IDAP REPORT – SECTION 4.55(2) MODIFICATION

Property:	42 Barker Road, Strathfield Lot: A DP: 313710 DA2021.172.3
Proposal:	Section 4.55(2) Modification Application – modifications to the approved dwelling house through amendment of Conditions 1, 6 and 10.
Applicant:	C Baini
Owner:	M Amcha
Date of lodgement:	13 May 2022
Notification period:	20 May 2022 to 3 June 2022
Submissions received:	One (1)
Assessment officer:	W van Wyk
Estimated cost of works:	\$2,076,140.00
Zoning:	R2-Low Density Residential - SLEP 2012
Heritage:	No
Flood affected:	Yes
RECOMMENDATION OF OFFICER:	APPROVAL

Figure 6: Approved First Floor Level (note: Condition 6 imposed to relocate Bedroom 1 to the void area and reduce the void around the stairs)

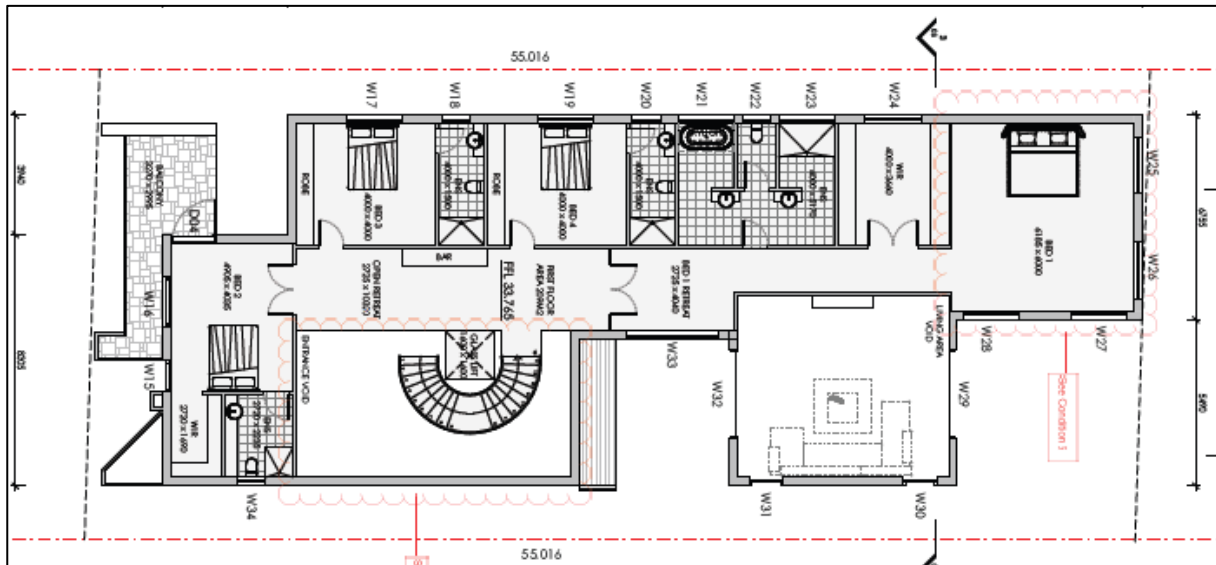
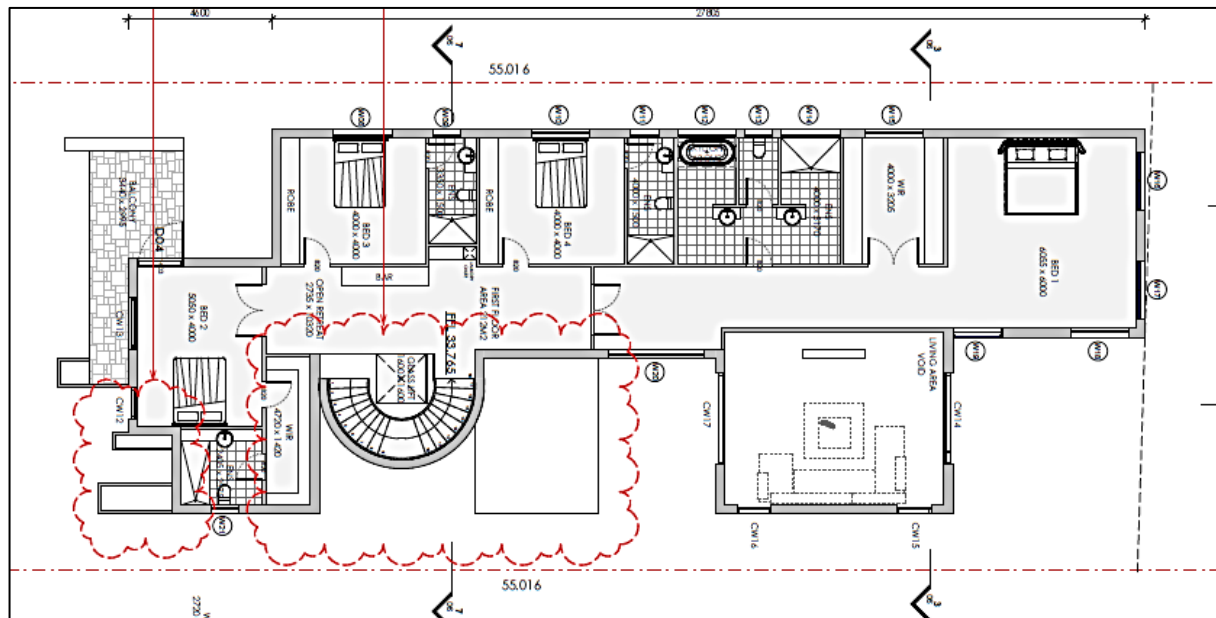
The proposed changes generally refine the approved design and can therefore be considered beneficial and facultative. The exception is retaining the void at the rear rather than repurposing this for Bedroom 1. The void is south and west facing and therefore does not provide a material amenity benefit for residents. The cantilevered location of Bedroom 1 is also not considered beneficial for surrounding properties. This aspect of the proposal is not supported.

Conditions 6(b) and (c) pertained to relocating the rear bedroom into a void area. This was imposed because the void did not provide a material amenity benefit for residents given it was west and south facing. Repurposing the void for Bedroom 1 also provides a deep soil and building bulk benefit compared to a rear extension. It is now proposed to revert back to the original design. As this would change a fundamental aspect of the approval, this change is not considered substantially the same and is not supported. As will be discussed throughout this report, these changes are also not supported on merit grounds. Accordingly, changing these conditions will not form part of the consent.

In summary, the proposed modifications are considered substantially the same, with the exception of the modifications to Conditions 6(b) and (c). This element of the proposal contravenes why the original proposal was accepted and is not supported.

Conditions 6(2)(b, c) were imposed because the void did not provide a material amenity benefit for residents given it was west and south facing. Any amenity benefits from a sense of grandeur and the like is outweighed by the loss of amenity from reduced landscaping and additional bulk and overshadowing. Any additional amenity impact arising from a poor design is considered inconsistent with Objective 4.1(B) of Part A of the SCDCP 2005 which requires developments to "minimise impact on the amenity of adjoining properties". It also contravenes Object (g) of the EP&A Act 1979 which seeks "to promote good design and amenity of the built environment".

Road and across the side boundary to 44 Barker Road. As indicated throughout this report, reinstating Bedroom 1 at the rear of the site is not supported and will be conditioned to remain over what is shown as a void area. This will remove this potential privacy impact and the remainder of the changes are considered acceptable.

Figure 8: Approved North Elevation (note: Condition 6 imposed to reduce the void around the stairs)

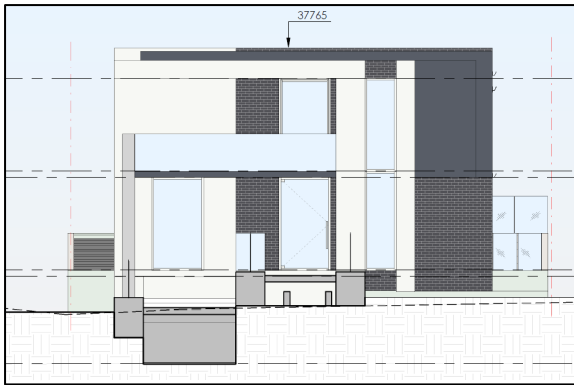
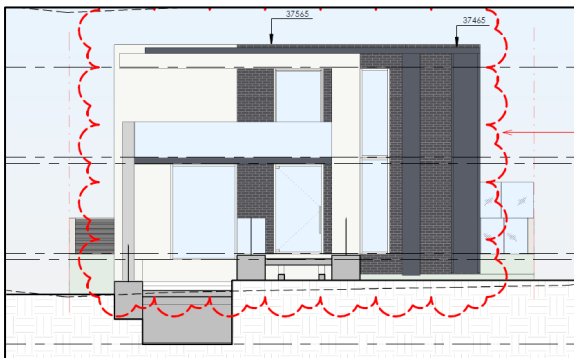
Condition 6(a) required the void above the front entry/stairwell be reduced. It is now proposed to taper the front façade and remove the void around the stairs entirely. This is consistent with the intent of the condition and will be assessed on merit later in this report. For the time being, it is enough to state that this modification remains substantially the same.

The tapering of the front façade will increase articulation and visual interest which will provide an improved architectural presentation. This is supported. A similar assessment can be made of removing the void around the stairs and this is assessed in more detail against the design planning principle later in this report.

Figure 10: Approved Eastern Elevation (note: Condition 6 imposed to relocate Bedroom 1 to the void area and reduce the void around the stairs, outlined in red)

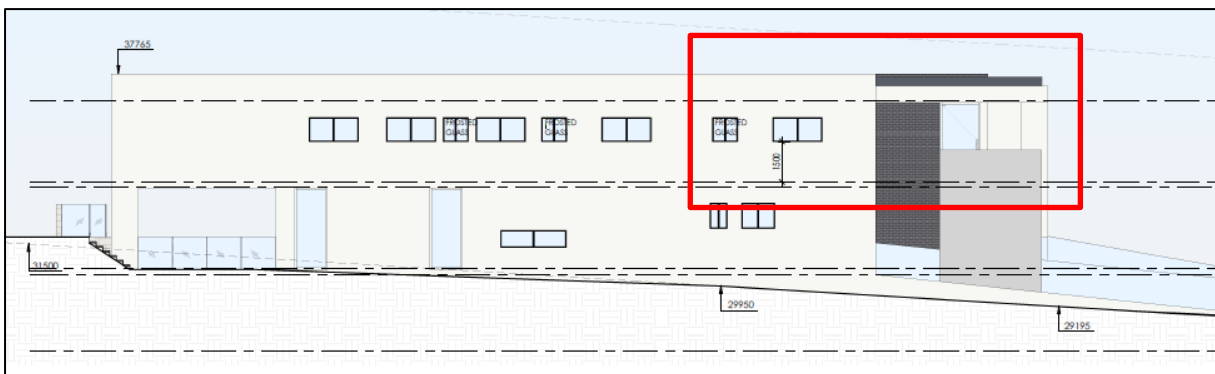
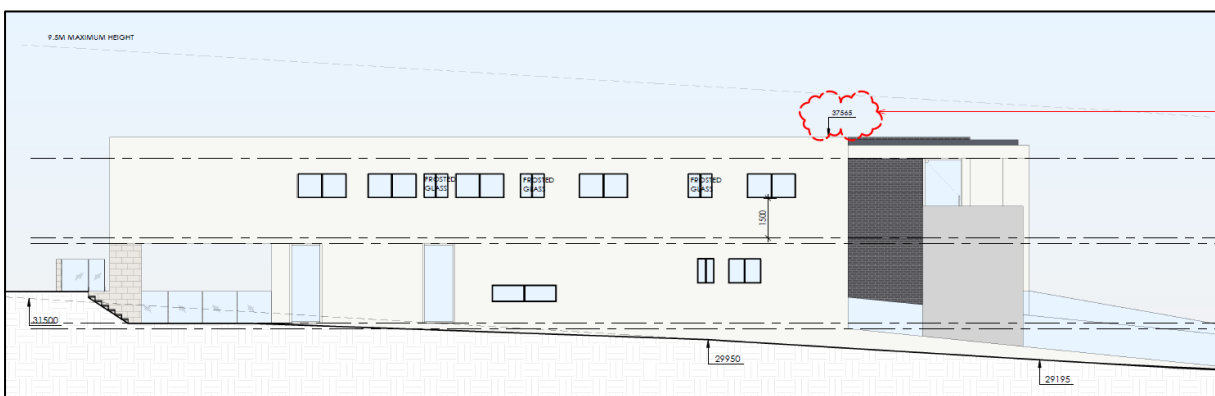
The proposal will reduce the roof height by 200mm and retain a similar flat roofed appearance. This will bring the roof into compliance with the 0.8m building envelope control. The material will change from a metal to a concrete roof finish. This additional variation in materiality increases the visual interest and is consistent with the relevant provisions in the SCDCP 2005. The proposed Bedroom 1 roof form is generally consistent with the provisions, however is not supported for the other reasons posited in this report.

Figure 14: Approved Western Elevation (note: Condition 6 imposed to relocate Bedroom 1 to the void area and reduce the void around the stairs)

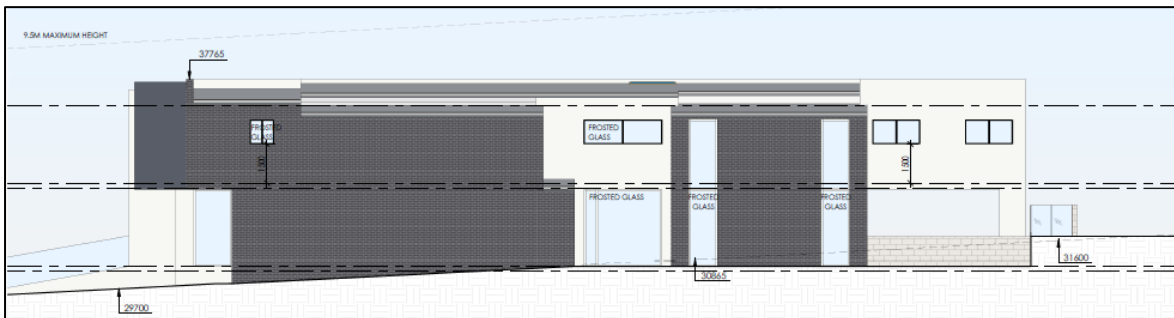
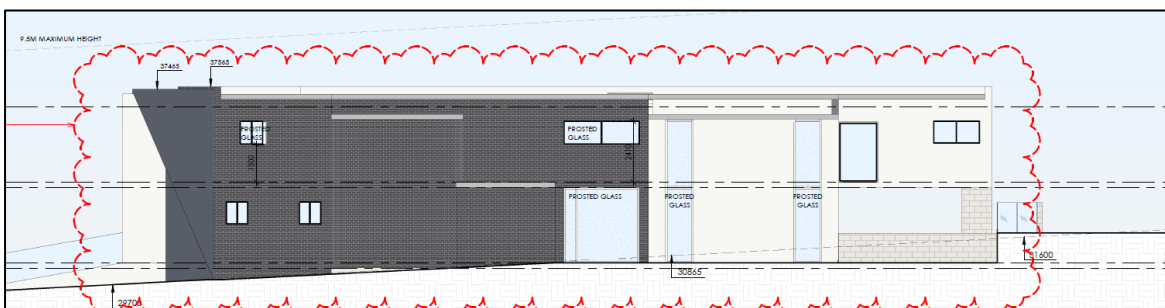
As indicated, the proposal is for the removal of Condition 6(a) which required the reduction of the ceiling height around the front entry and stairwell. It is proposed to taper the front façade as per the condition and remove the void entirely, going beyond what was required in the condition. While the tapered front façade will reduce streetscape bulk and provide additional articulation, the removal of built form around the stairs creates an inconsistent and unusual western elevation.

Overall, the proposal will maintain or improve visual amenity, with the exception of the rear extension which is not supported. While the modifications to the western façade create an unusual design, this remains consistent with the considerations in the design planning principle.

The proposed modifications will not change the previously approved materials along the western elevation, other than the roof form. The materials also do not contribute to overshadowing. Accordingly, this objection is not relevant. Reducing the built form around the stair may even increase natural light for 44 Barker Road.

Figure 22: Section showing ground floor, first floor and void space ceiling heights

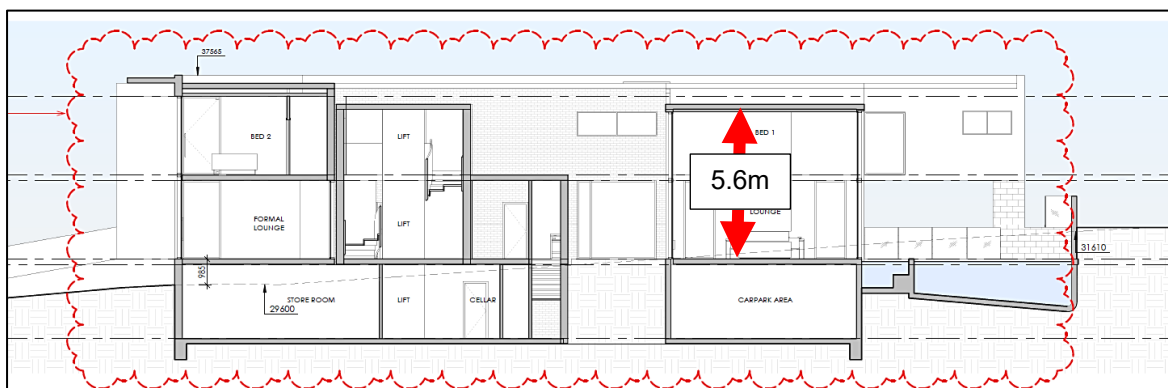
Part A4.2.2(5) contains an internal ceiling height control of 3m for any residential level. The proposed modifications retain a 3m ceiling height as approved, except for the following:

- A minor reduction above the lift and stairs area; and
- A significant increase by reinstating the void at the rear.

As approved, the rear living area void was to be repurposed for Bedroom 1. The relocation of Bedroom 1 to a cantilevered element would result in the rear lounge area having a floor to ceiling height of 5.6m, which represents a 87% breach (see **Figure 22**). It is noted that, although the Section shows 'Bed 1' above the lounge, this appears to be a misprint given no floor is shown. The floor plans clearly demonstrate the area above the rear lounge being a void and the assessment is carried out on this basis.

The ceiling height breach is not supported as compliance can readily be achieved by relocating the cantilevered Bedroom 1 into the void. The large void area unnecessarily contributes to the bulk of the development and is inconsistent with the objectives of the building envelope controls, as assessed above.
